Addendum/Addenda

No./N° 2

Project Description / Description de projet M19 Stores Amalgamatim Phase 1		
Solicitation No./ N° de sollicitation 17-22098	Project No./N° de projet 5463	W.O. No./N° d'ordre de travail A1-009909/99
Departmental Representative / Représentant Ministériel Janik Leroux	Date November 29, 2017	
Notice: This addendum shall form part of the tender documents and all conditions shall apply and be read in conjunction with the original plans and specifications.		Nota: Cet addenda fait partie intégrale des dossiers d'appel d'offres; toutes les conditions énoncées doivent être lues et appliquées en conjonction avec les plans et les devis originaux.

dwg.no. 5463-A01 dessin no.

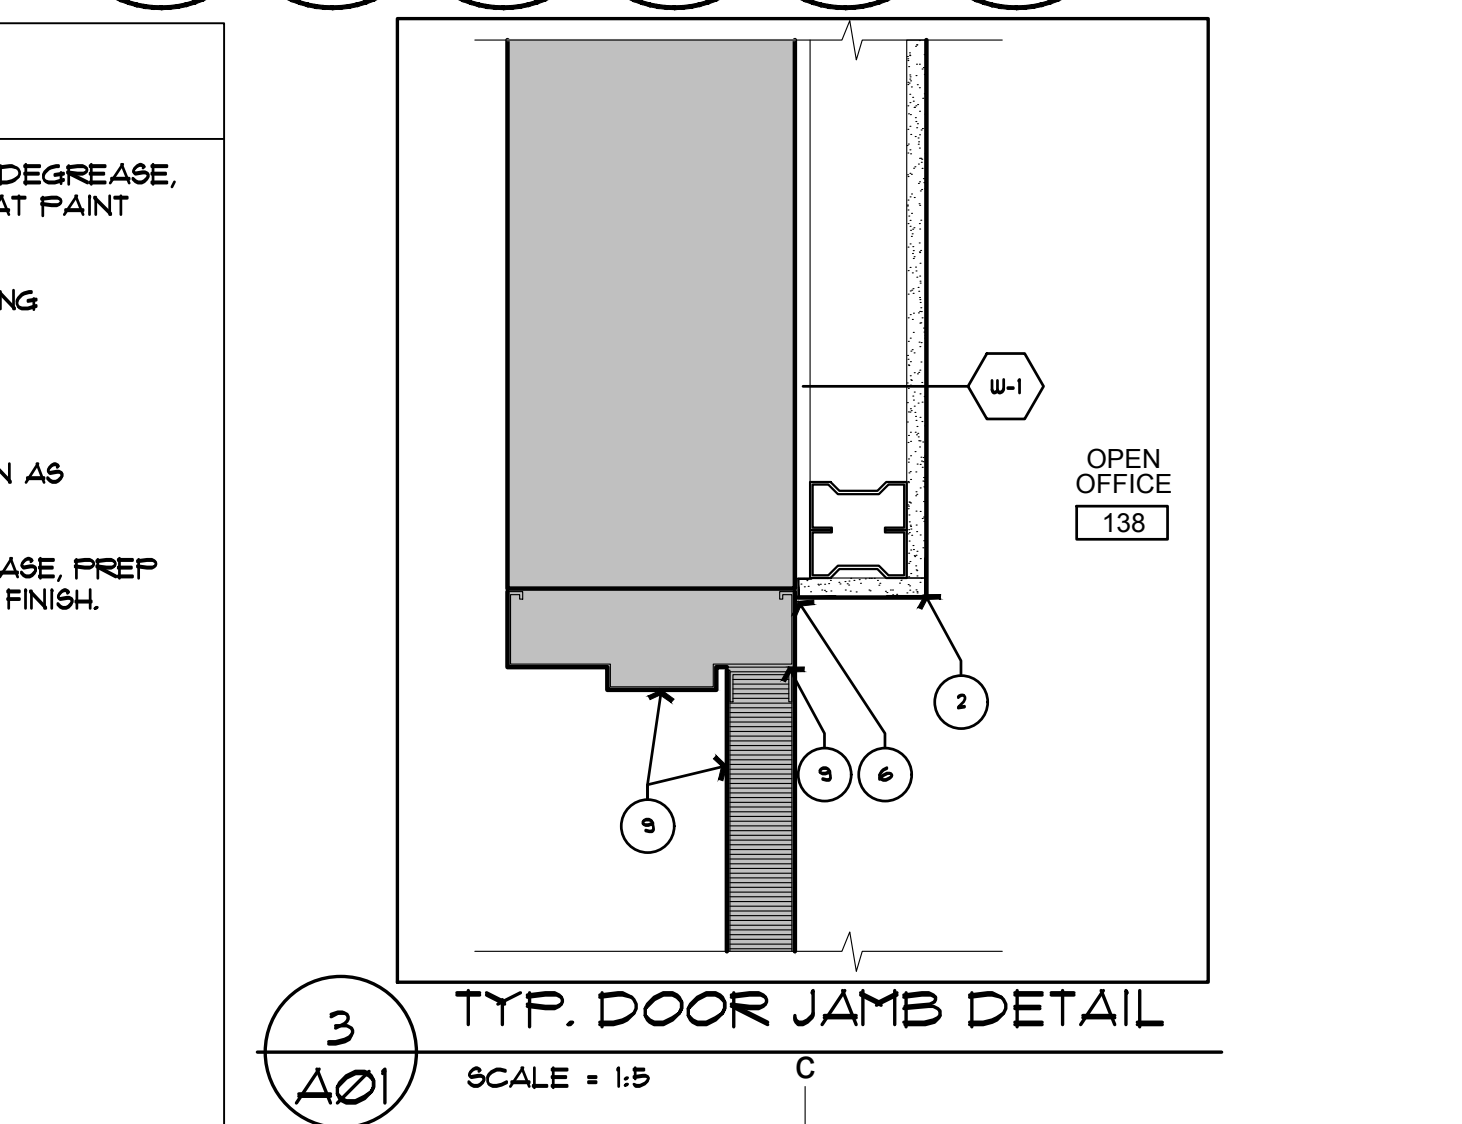
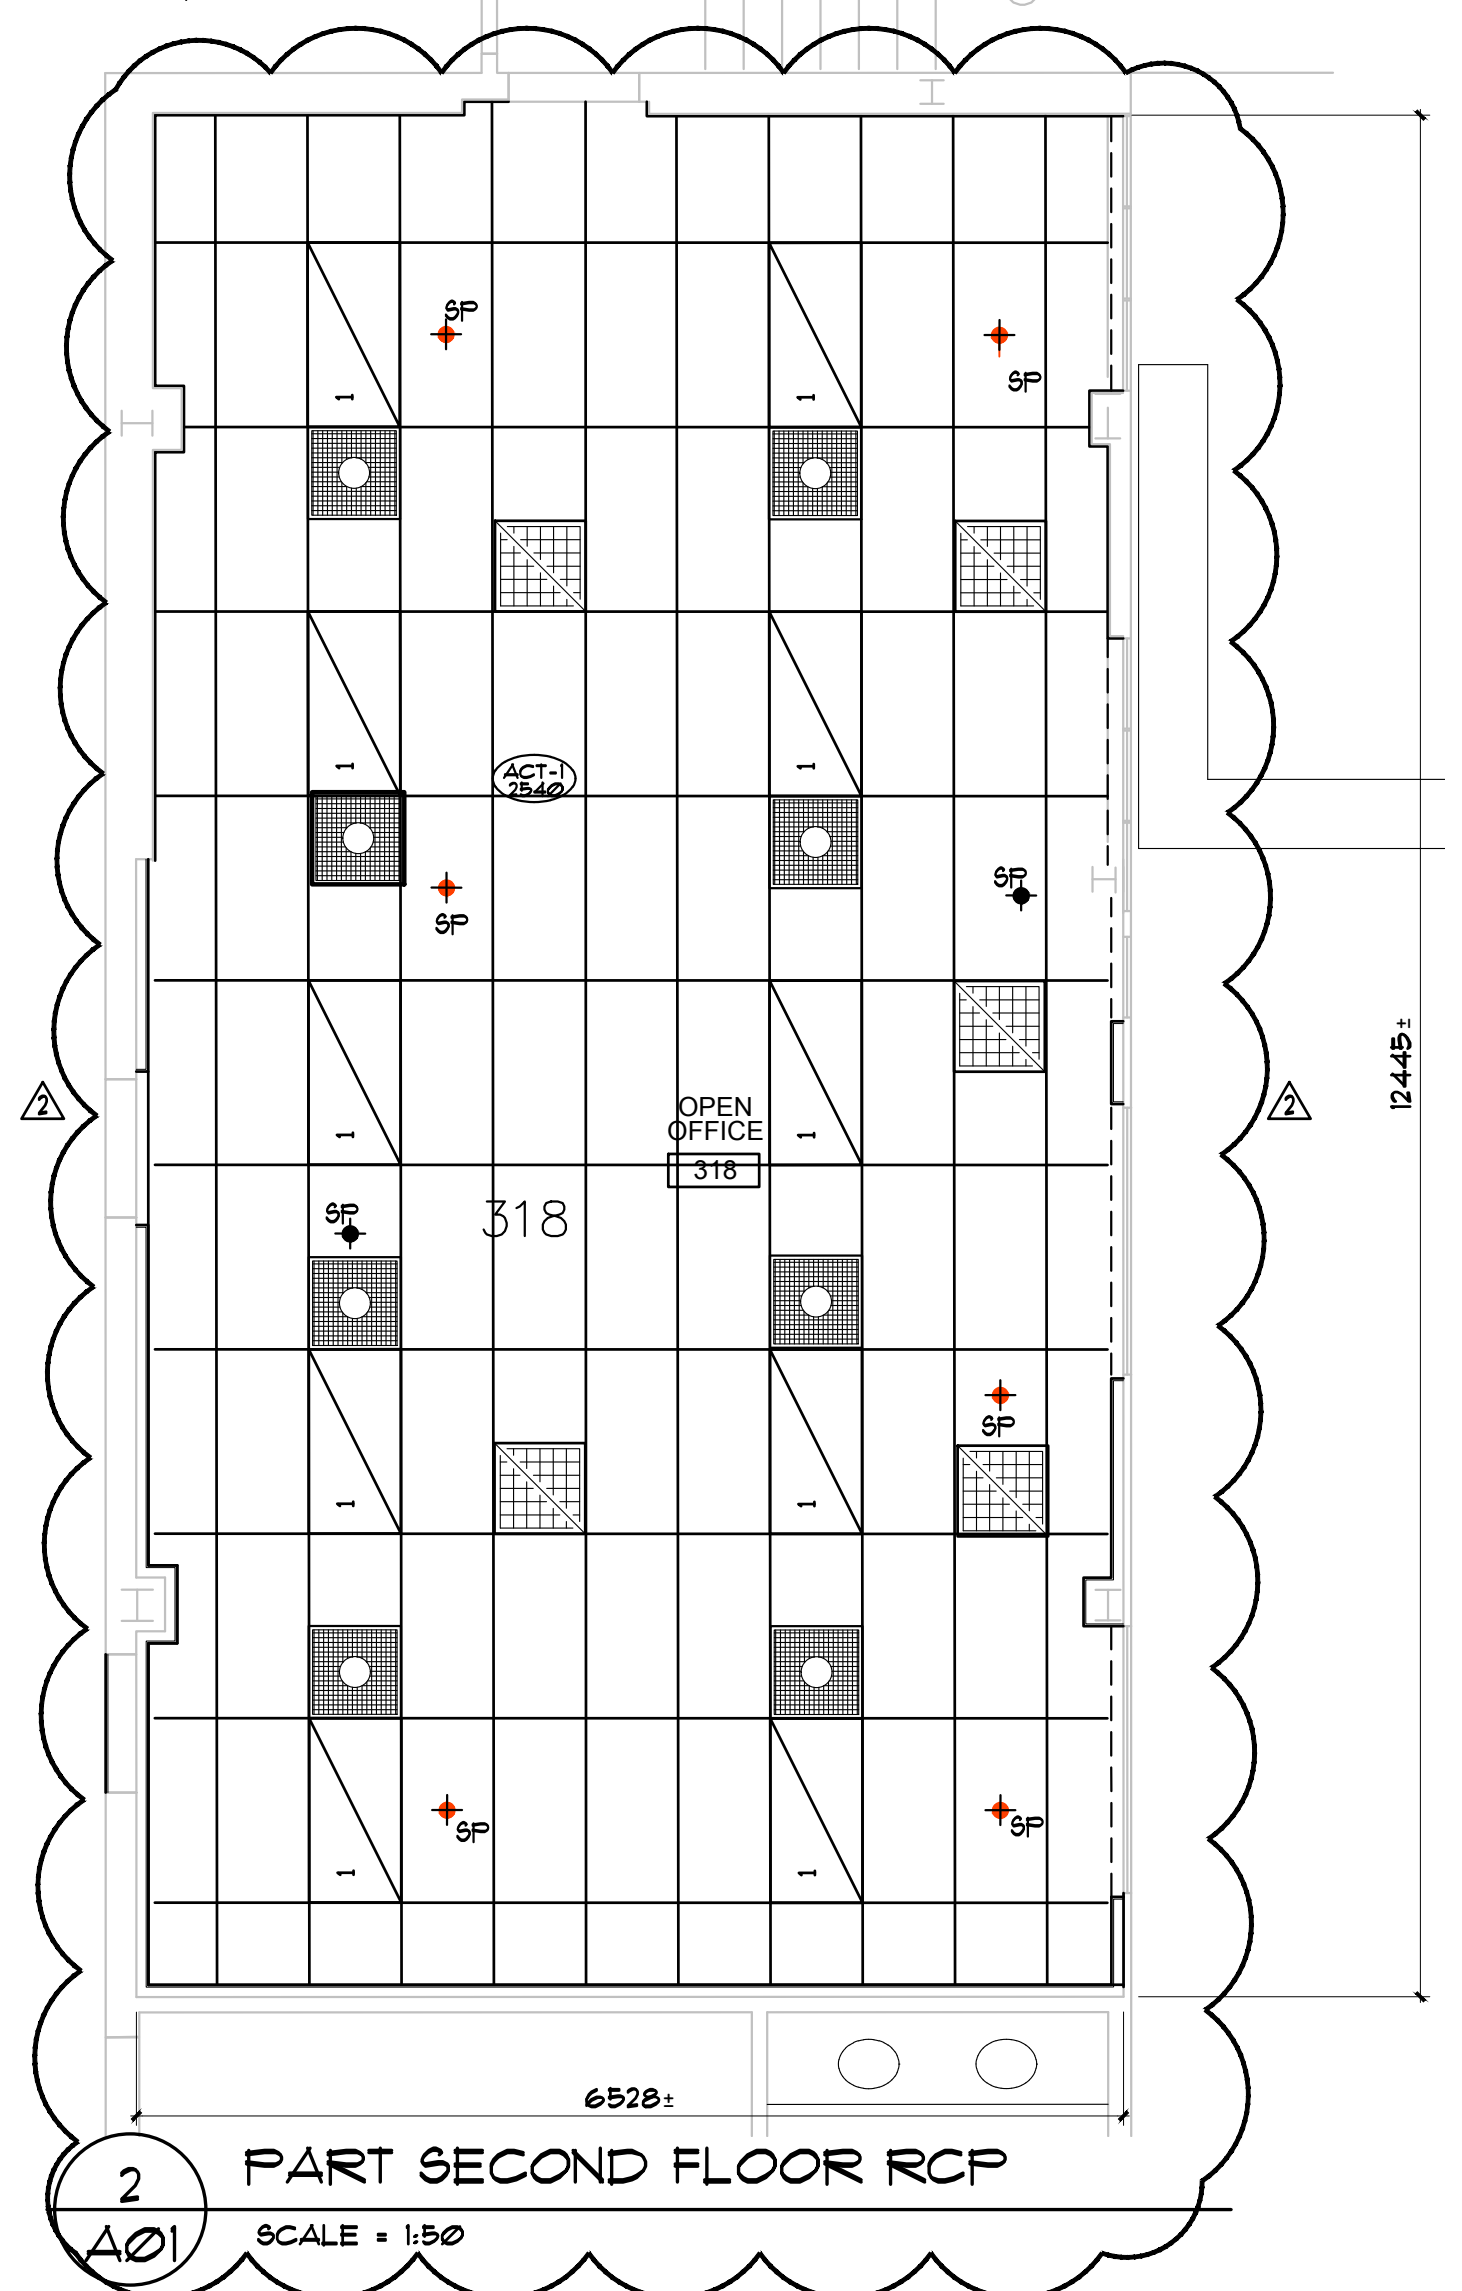
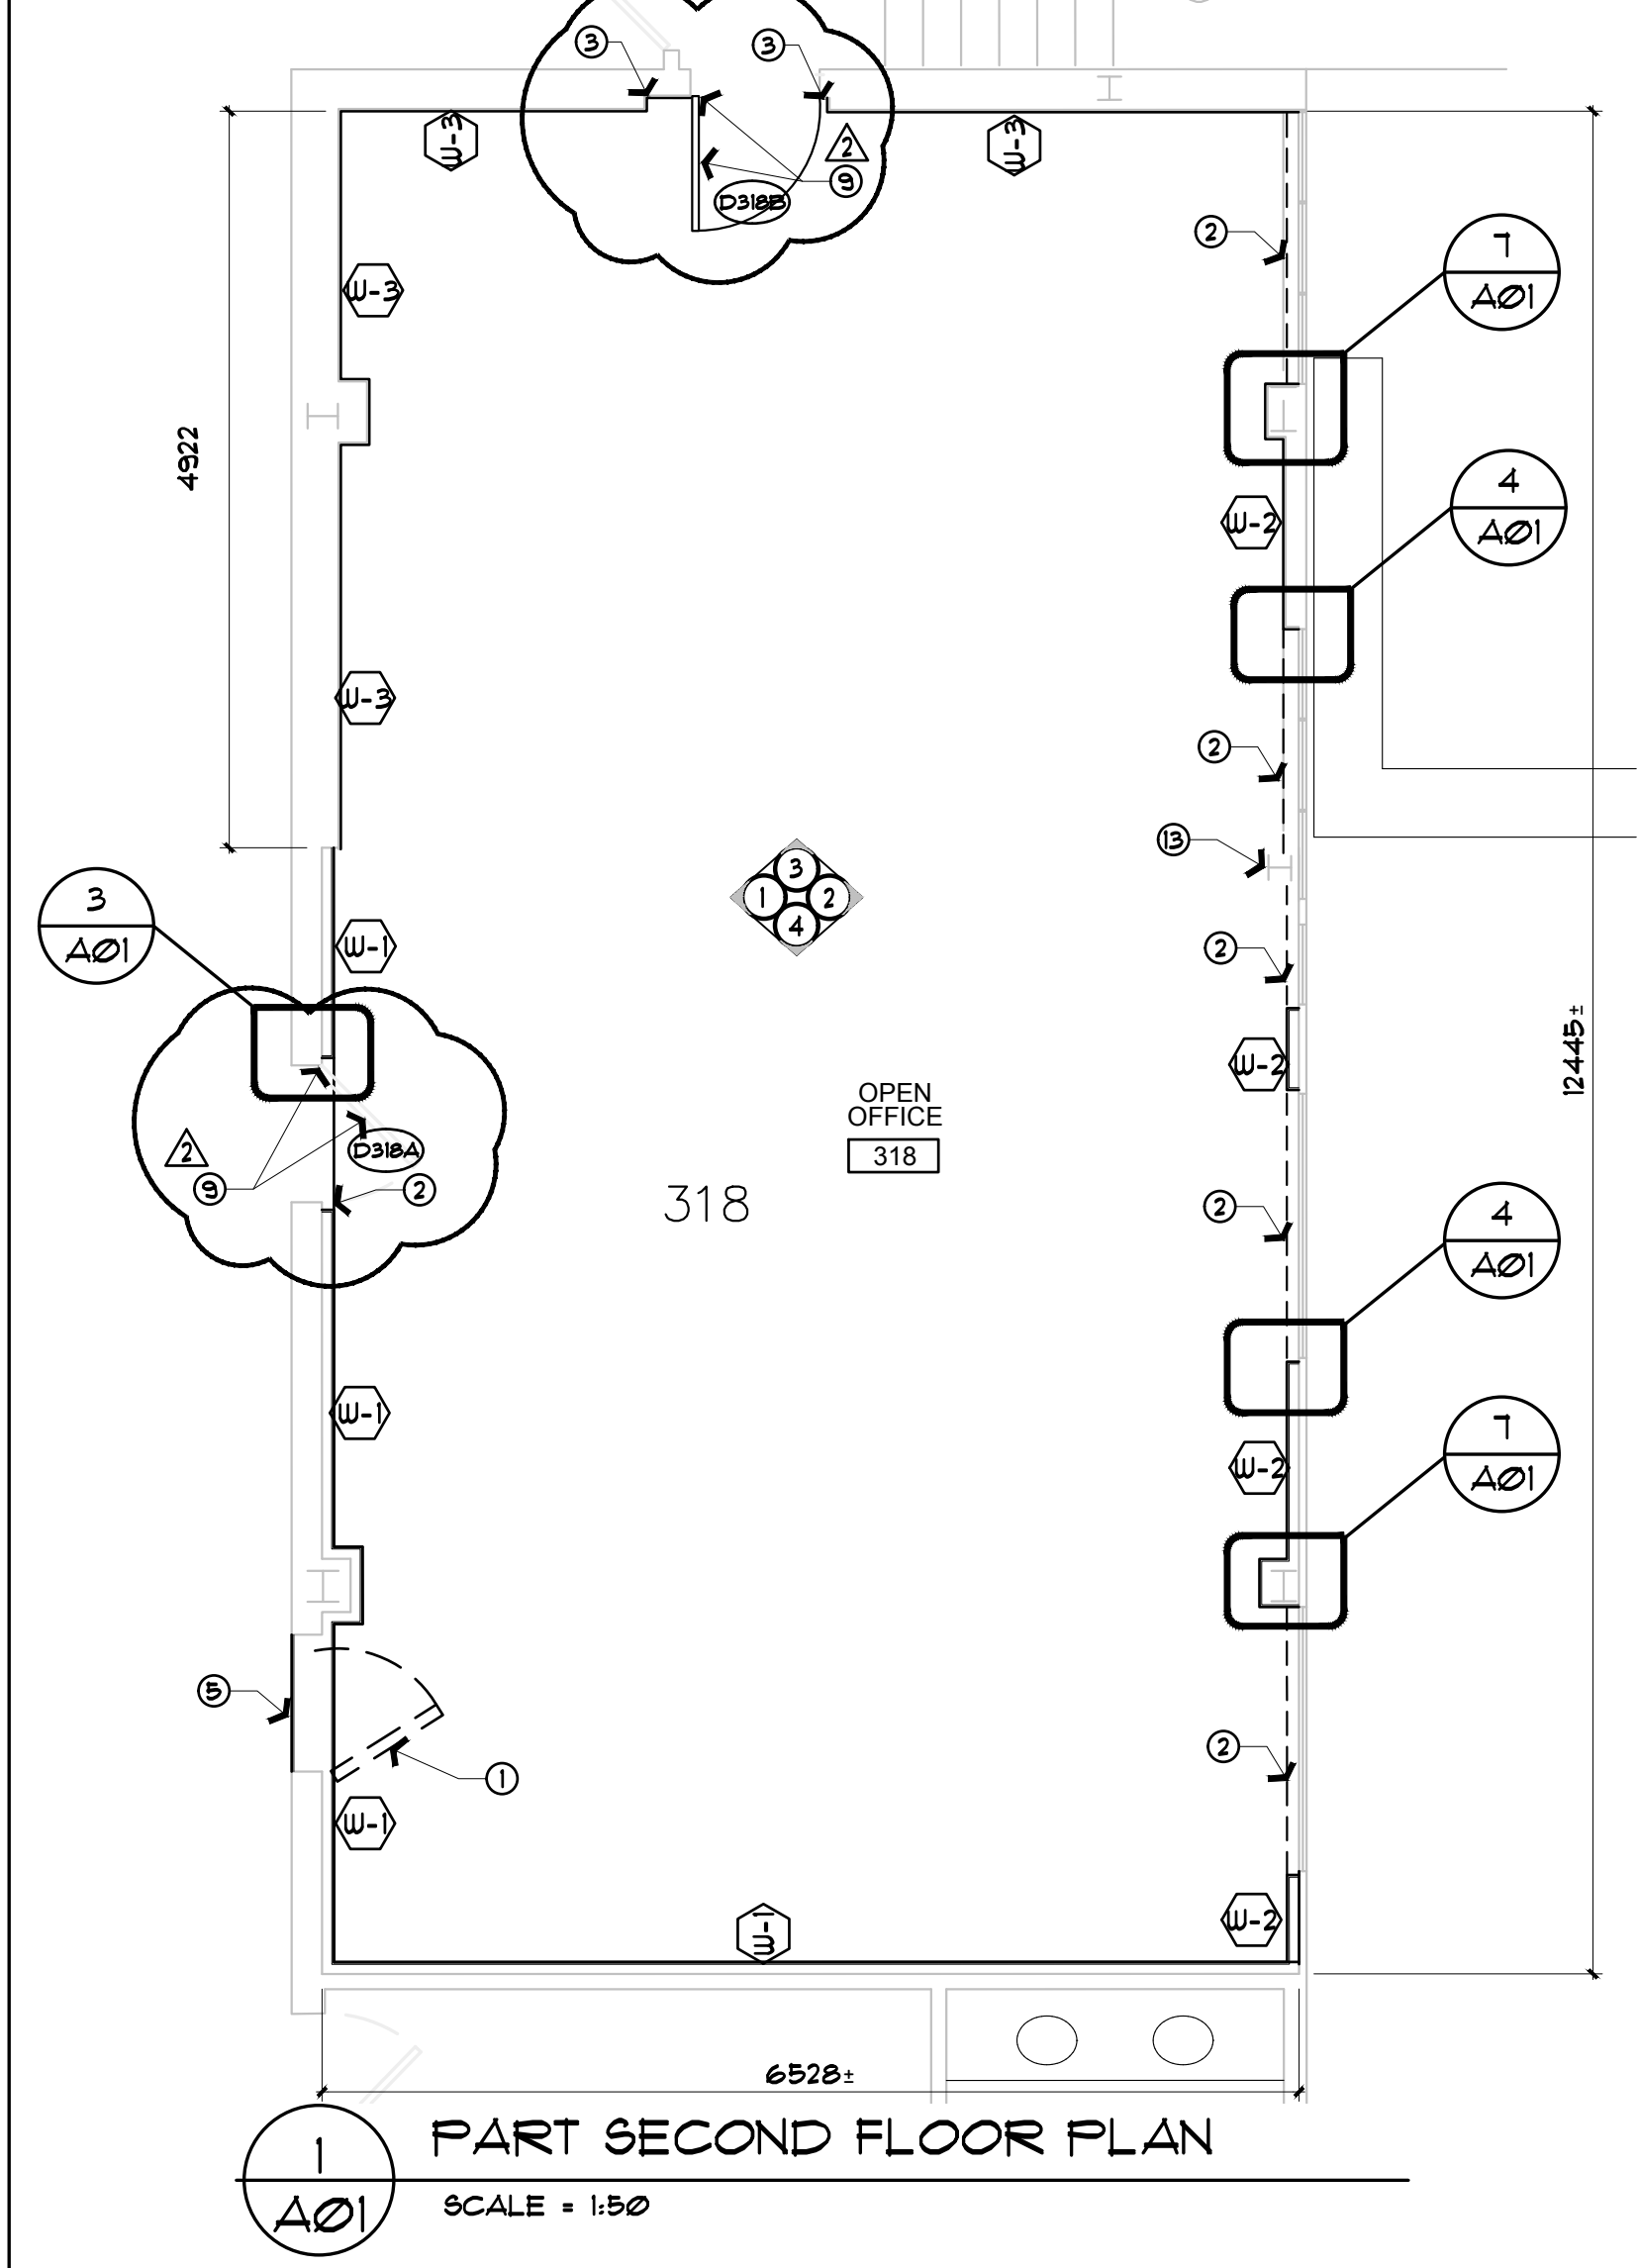
1. Job Showing sign in sheet is attached.
2. Questions from bidders:
 - a. Do you have specs for the new 25mm window blinds and valance?
Answer: Refer to Addendum #2
 - b. On drawing 5463-A01 construction note 1 is shown at door 318B which states "Remove existing door, frame to remain". On drawing 5463-A03 in the Door Schedule 3/A04 it indicates door 318B as existing to be painted and to receive graphic window film. Please advise if door is to be removed as per note 1 or to remain as noted in door schedule.
Answer: notes and arrows have been revised on drawing 5463-A01, refer to Addendum #2

- a. Replace original tender drawing with attached Addendum #2 drawing 5463-A01.
 - i. Changes from tender issue have been clouded.
2. Specifications:
 - a. Add attached Section 12 21 12 – Horizontal Louver Blinds

- ### CONSTRUCTION NOTES
- SHEET A01 ONLY
- REMOVE EXISTING DOOR, FRAME TO REMAIN.
 - FRAME OUT AROUND EXISTING WINDOW AND DOOR FRAMES, GYPSUM BOARD RETURN CAJ J-MOULD AND METAL CORNER BEADS. PAINTABLE SEALANT BETWEEN EXISTING WINDOW FRAME AND J-MOULD.
